# Recall Bulletin 170317REV

**PRODUCT(S) AFFECTED:**  
Fleetwood  
Bounder

**MODEL(S) AFFECTED:**  
35 P

**SUBJECT:**  
Replacing the  
Manufacturer  
Federal  
Certification Label

**Figure 1**

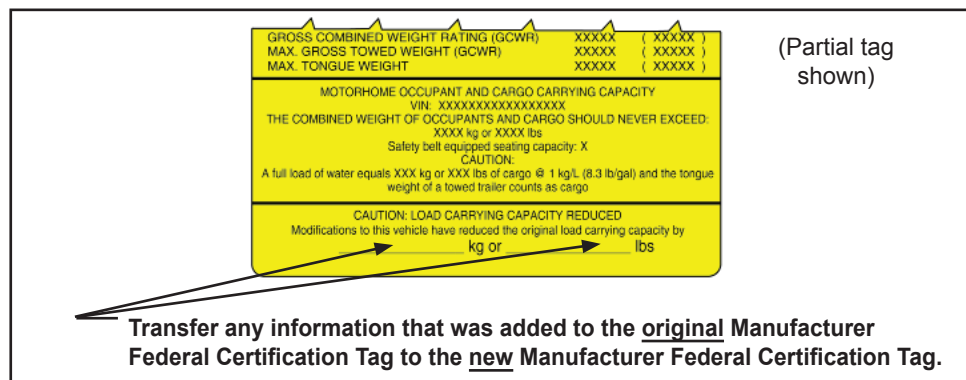
On motor homes affected by this recall, the Federal Certification Tag figures related to the front and rear tire sizes are incorrect. The incorrect tire size is “235/80R 22.5 G”; the correct tire size is “255/80R 22.5 G”.

1. Locate the original Federal Certification Tag, adhered to the wall behind the driver’s seat.
2. Record any additional weight information (if present) that was written on the original Manufacturer Federal Certification Tag due to the addition of dealer-installed options after the motor home was manufactured. (See Figure 1.) Transfer this information to the new Manufacturer Federal Certification Tag using a black, fine point, permanent marker.

Retail owners of affected motor homes and dealers holding affected motor homes in inventory will receive a package from REV Recreation Group containing a new and corrected, **serial number specific**, Manufacturer Federal Certification Tag. Verify eligibility by referring to the affected motor home serial numbers listed at the end of this Bulletin before applying new labels.

3. a) If the original Federal Certification Tag is loose or peeling, remove it and discard. Remove any adhesive residue in the application area using a clean shop cloth slightly dampened with isopropyl alcohol.  
b) If the original Federal Certification Tag is adhered securely in place, use a black permanent marker to deface it.
4. Peel and tear approximately 1" from the top of the adhesive backing of the new Federal Certification Tag. (This will allow control of the application.) Slowly apply the new Tag directly over the original, using your fingers to smooth down newly-applied areas. (If the original Tag was removed in Step 3a, apply the new Tag in the same location as the original.) Continue to remove backing, working from top to bottom, until the entire tag completely adheres to and covers the original tag.
